STAFF REPORT: 02/11/2026 REGULAR MEETING

APPLICATION NUMBER: HDC2025-00740

ADDRESS: 19597 SHREWSBURY

SCOPE: REPLACE WOOD WINDOWS WITH ALUMINUM-CLAD WOOD WINDOWS

Staff photo, 02/05/2026

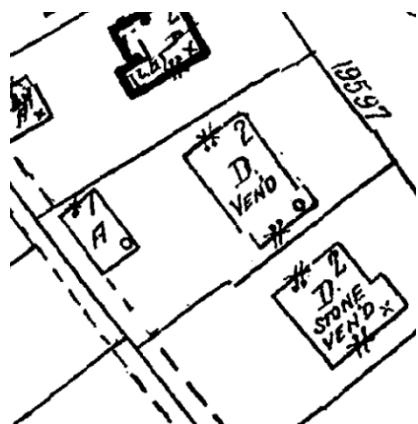
- Replace seven (7) existing wood windows with new aluminum-clad wood windows
 - Location: second story at façade and sides
 - Operation and design: double-hung with 6-over-6 simulated divided lite
 - Color: white
